RESPONSE TO REQUEST FOR ADDITIONAL INFORMATION

APR1400 Design Certification

Docket No. 52-046

RAI No.: 416-8358
SRP Section: SRP 19
Application Section: 19.1
Date of RAI Issued: 02/23/2016

Figure 19.1-22 Level 1 Event Tree - General Transient (GTRN)

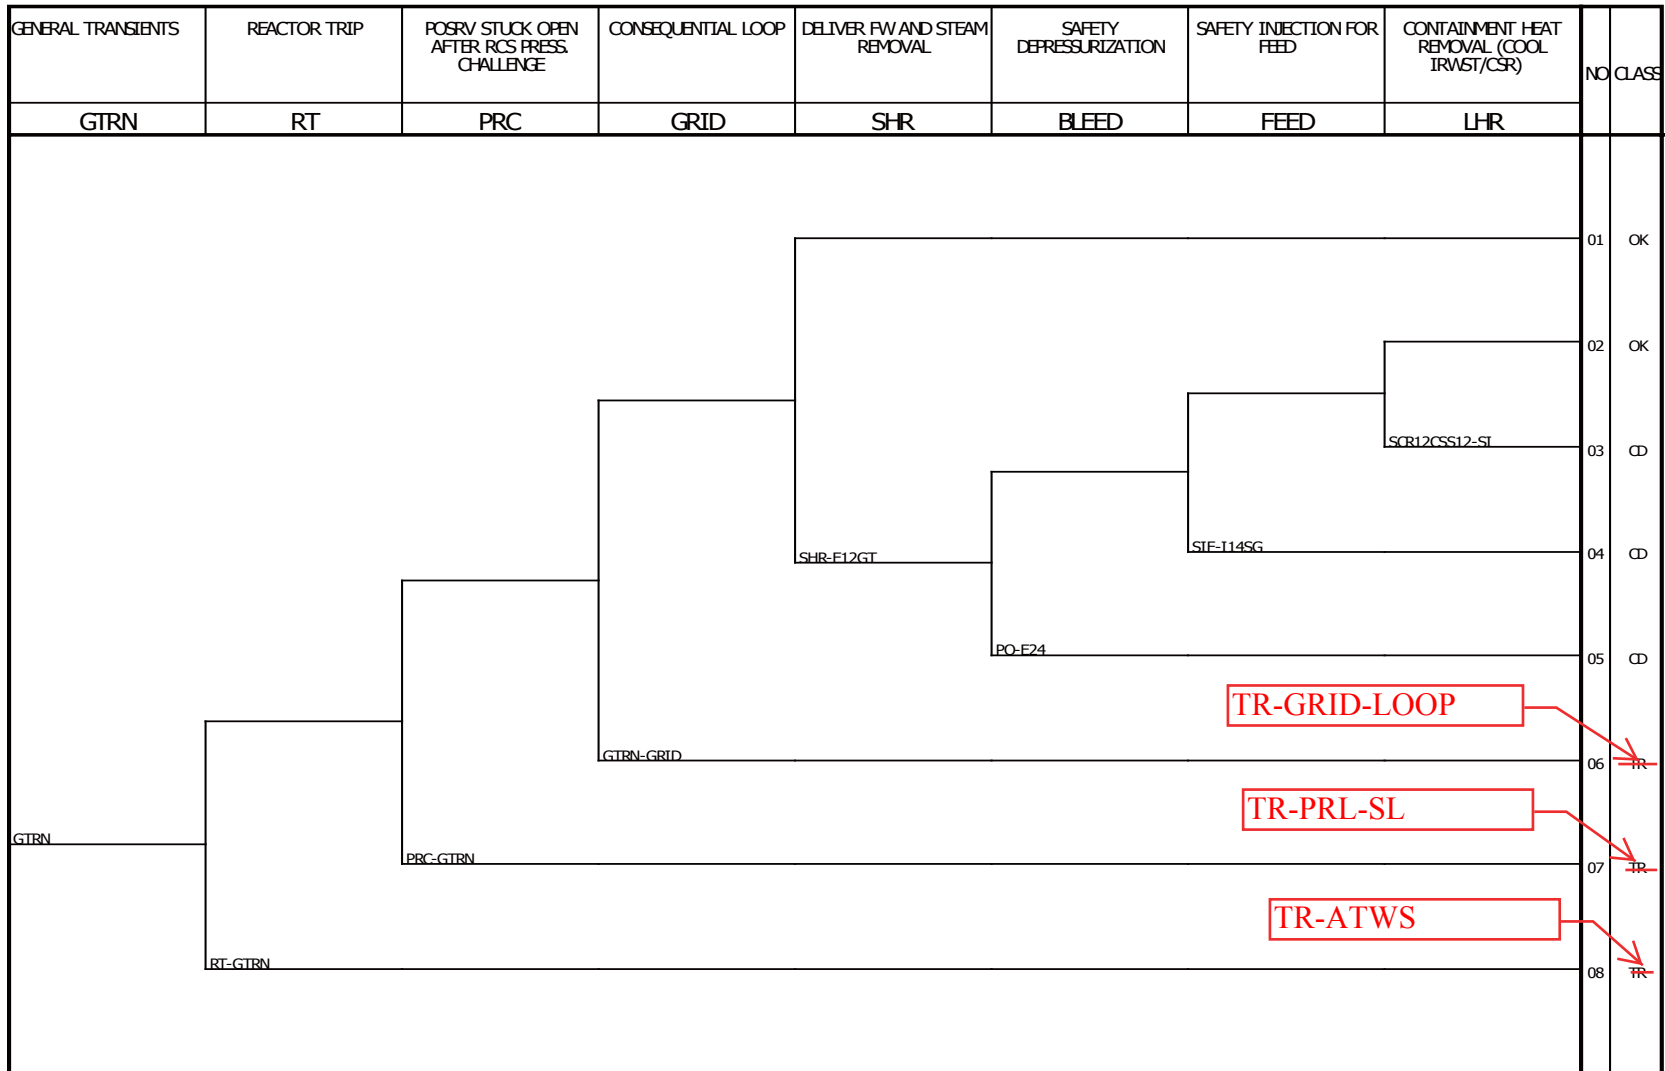
- 1 The applicant did not describe the method used to implement event tree transfers
- 2 The transfers shown in the event trees to not identify the trees they transfer to
- 3 The applicant did not justify accident sequences with reactor trip failure that ended in core damage (ASME/ANS PRA Standard supporting requirements – AS-A11).

2. The pictures of the event trees provided in the DCD with transfer sequences will be revised to identify the event tree to which it is being transferred. Attachment 2 contains the revised event tree pictures.

The revised pictures include an identifier to indicate to which event tree the sequence is transferred. Obviously, transfer sequences which include failure of reactor trip transfer to the ATWS event tree (TR-ATWS), transfer sequences which include stuck open POSRVs transfer to the stuck-open POSRV event tree (TR-PR-SL), transfer sequences which include consequential LOOP transfer to the consequential LOOP event tree (TR-GRID-LOOP), LOOP sequences with failure of all DGs transfer to the SBO event tree (TR-SBO), and finally GRID-LOOP sequences with failure of all DGs transfer to the GRID-SBO event tree (TR-GRID-SBO).
